FROM: PARKER MEGGITT TECHNICAL PUBLICATIONS

TO: HOLDERS OF SB 1111548-25-001-2023 FOR THE RESTRAINT SYSTEM

TRANSMITTAL SHEET

REVISION 001 dated Dec 01/23

Figure 2
Flowchart of Required Operator Action

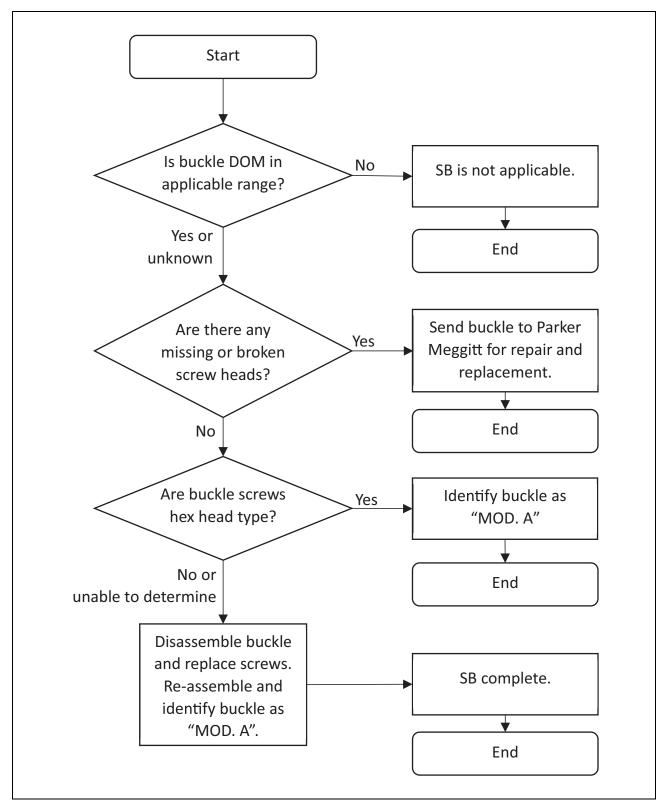
Chapter/Section	Description of Change	Effectivity
Page No.		
1	Updated paragraphs 1.A.(1). and 1.A.(3).	_
2	Modified 'Date of Manufacturer (DOM)' to 'Date of Manufacture (DOM). Updated paragraph 1.B.(2).	
6	Updated paragraph 1.D.(3). Added 'Front View' and 'Back View' text in Figure 1.	_
7	Deleted step (a) from Conclusion and Corrective Actions.	_
8	Added more inspection criteria in Suggested Operation Action section.	_
9	Updated flowchart (Figure 2).	_
10	Replaced 'faulty screws' with 'suspect screws'. Updated Warranty Information. Replaced 'reassembly' with 'reassemble'.	_
11	Updated Other Publications Affected.	_
12	Updated 3.A. Added website link. Added note under Material Necessary for Each Component. Updated Re-identified Parts / Existing Parts Accountability.	_
13	Updated formatting of section 4.B. Revised inspection procedure.	_
15	Updated Figure 6.	_
17	Replaced 'faulty screws' with 'suspect screws'. Added note and reference to figure.	_
